Figure 1: Comparison of refused Application 1 and proposed Application 3 (architect's drawings)

The text below reiterates my objections to this aspect of Application 1 (2017/6726/P) and Application 2 (2018/2136/P) and Application 3 (2018/3114/P).

Figure 2: Comparison of refused Application 1 and proposed Application 3 (architect's drawings)

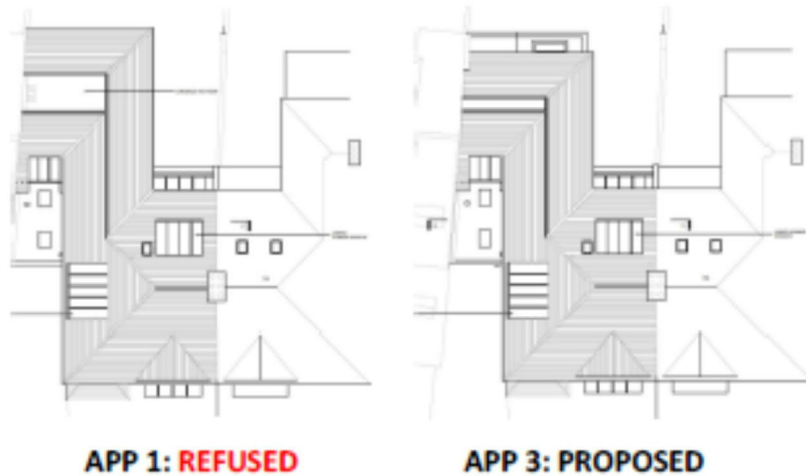
Figure 1 demonstrates the small overall difference between the refused Application 1 and Application 3.

Any extension is building onto an existing outrigger. The proposed rear development when added to the existing outrigger takes the total depth to 8.65 metres at ground storey level and 7.24 metres at 1st floor level. The introduction of the 1-storey flat roof section thus reduces the total outrigger depth at 1st floor level by only 16% (from 8.65 metres to 7.24 metres), compared with Application 1.

This reduction, which only relates to 3.7 metres of the overall 6.4 metre width of the rear extension, does not address the issues highlighted by Camden Planning when refusing Application 1. The proposed rear extension does not respect and preserve the original design and proportions of the building: the bulk, scale and mass are disproportionate.

The slight difference between Applications 1 and 3 is also highlighted by the roof drawings. The bulk, scale and mass of the proposed extended pitched roof barely differs between the two applications and is hugely extended from the existing roofscape.

The proposed rear extension should be refused.

A one-storey infill extension, along the lines of what was included in Application 2 (2018/2136/P), would avoid this issue.

Figure 2: annotated excerpt from submitted plans

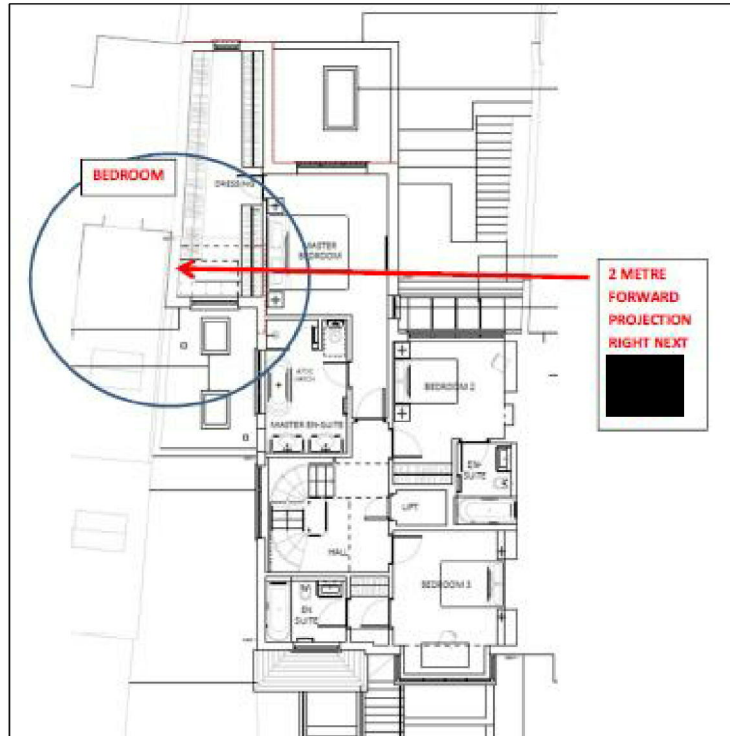
I object to the proposed 1st floor front projecting extension abutting my house. This extension will project forward by about 2 metres along the boundary wall [REDACTED] (see Figure 2).

The room that is referred to in this comment is not a bathroom, it is a bedroom. The fact it is dual aspect at the back is irrelevant to the way the proposed 1st floor extension at No. 75 will be overbearing and create a sense of enclosure as I will be looking out through a tunnel effect that will 'box' me in. **It is not acceptable to allow a 2 metre projecting extension along a boundary right next to a bedroom window (see Figure 2).** The edge of my window will be just 70 cm from the new 2 metre projection. It seems particularly unnecessary for No. 75 to have this front projection because that 1st floor room is shown on the application plans as a wardrobe/dressing room.

It is factually incorrect that there are other examples within the street scene whereby properties have projected forward at first floor (Nos.72, 73 and 74 part of this terrace). Specifically, the 1st floor vertical planes above the side garages of the houses at 73 and 74 Lawn Road are the original 1920s building – **there have not been any alterations in the position of these walls since these houses were built.** At 72 the vertical face of the newer 1st floor side extension was built to match 73 and 74. As the applicants at 75 pointed out in their original planning application, the position of the vertical face of the existing side extension at 75 is identical with its historic position according to old plans. **It should not be moved to a new position as this will have an adverse impact on my amenity, as explained above.**

A 2 metre front projection plus front dormer is not a ‘modest extension’ and a new front dormer would set a precedent. It will create the only example along this row of 1920s Arts & Crafts style houses where the 1st floor side elements of two adjacent houses are not flush with each other (i.e. in the same vertical plane). This will look incongruous from the street.
